Access Compliance Report

Public Rights-of-Way

(Curb Ramps)

Intersection ID: 46193	Main Street: GALARDIA_RD	Cross Street: SEVEN_OAKS_DR	Location: NE
ADA ID: 9973B1D5115F	Ramp Type: BlendTrans1	Initial Pass/Fail: Pass	Overall Compliance: No
			Severity Score: 20.25

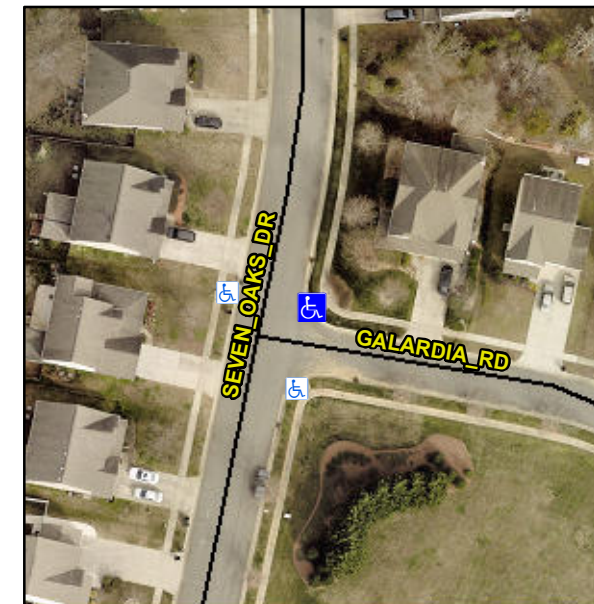
CURB GAP 1.0

Not Found, R304.5.3, R304.2.1, R305.2, R302.7.2, R304.5.4

Remove & Replace Curb Ramp With Two New Directional Ramps or Equivalent. Remove & Replace Gutter.
